Product Change Notification / CENO-28OKTD637

CCB 6719 Final Notice: Qualification of MTAI as a new assembly site for selected SY100EP111, SY100EP195V, SY100EP196, SY89295U and SY89296 device families available in 32L TQFP (7x7x1.0mm) package.

Pre and Post Change Summary

ANAP

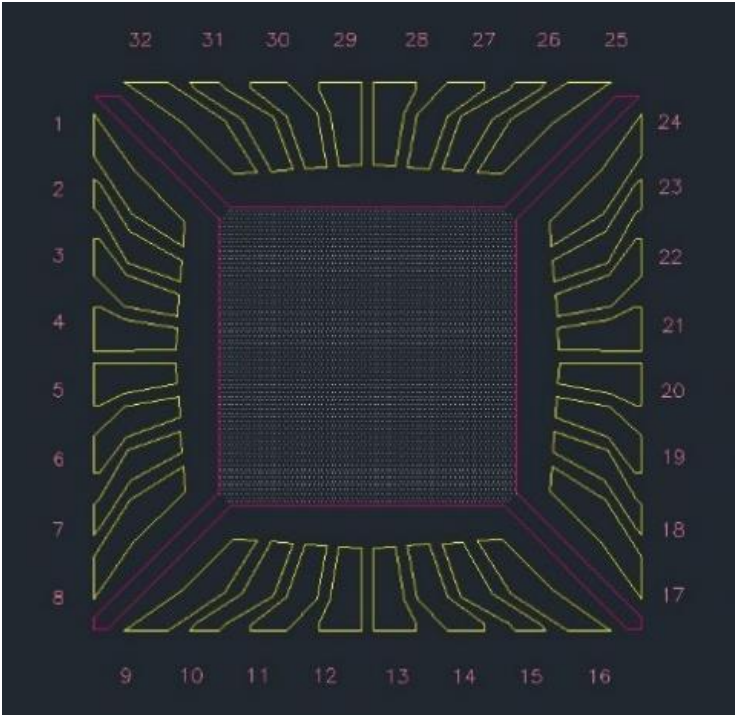
Lead Frame Material	C194
Paddle size	138 x 138 mils
DAP Surface Prep	NiPdAu

MTAI

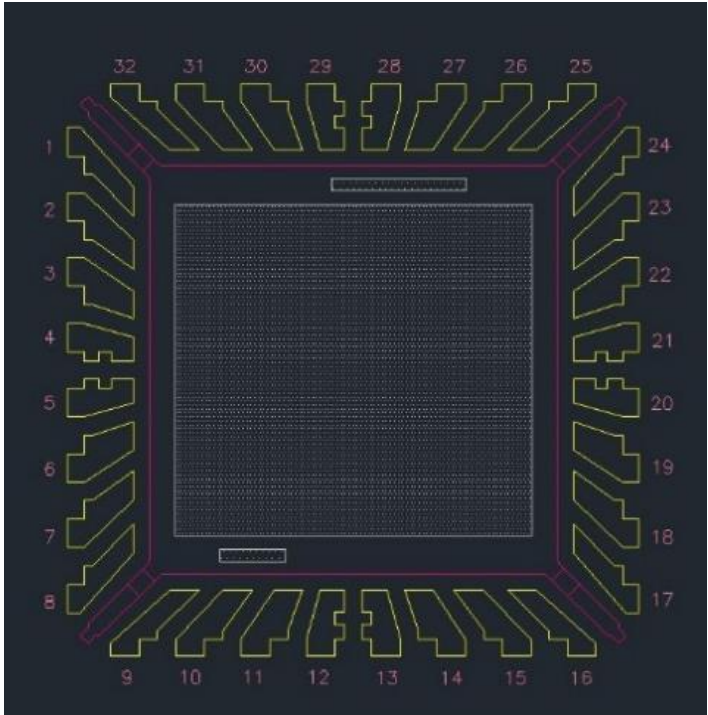
Lead Frame Material	C7025
Paddle size	197 x 197 mils
DAP Surface Prep	Ag selective

TRAY COMPARISON

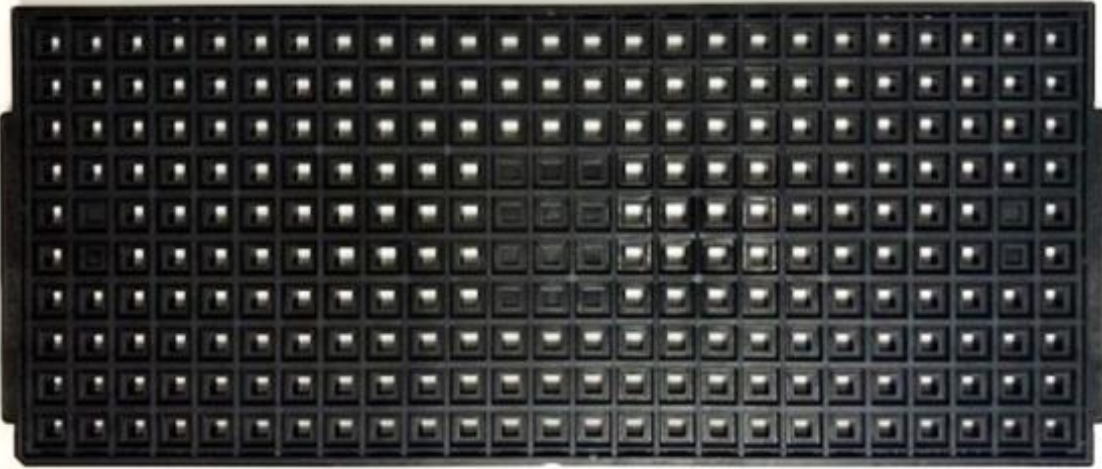
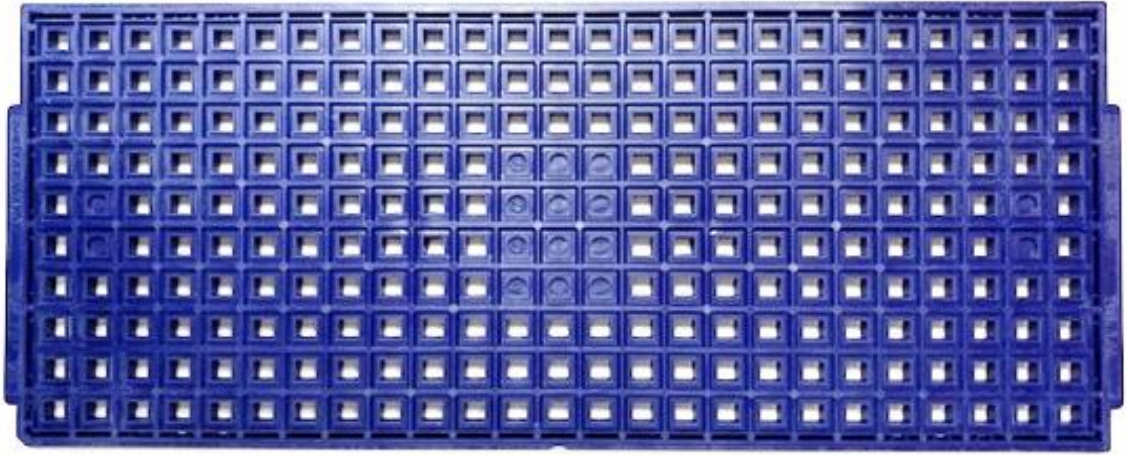
ANAP	MTAI								
 <p>A black plastic tray with a grid of 100 square compartments, arranged in 10 rows and 10 columns. The tray has a slightly raised edge on the left side.</p>	 <p>A dark blue plastic tray with a grid of 100 square compartments, arranged in 10 rows and 10 columns. The tray has a slightly raised edge on the left side.</p>								
<table><tr><td>Color</td><td>Black</td></tr><tr><td>Baking</td><td>Bakeable</td></tr></table>	Color	Black	Baking	Bakeable	<table><tr><td>Color</td><td>Dark Blue</td></tr><tr><td>Baking</td><td>Non-bakeable</td></tr></table>	Color	Dark Blue	Baking	Non-bakeable
Color	Black								
Baking	Bakeable								
Color	Dark Blue								
Baking	Non-bakeable
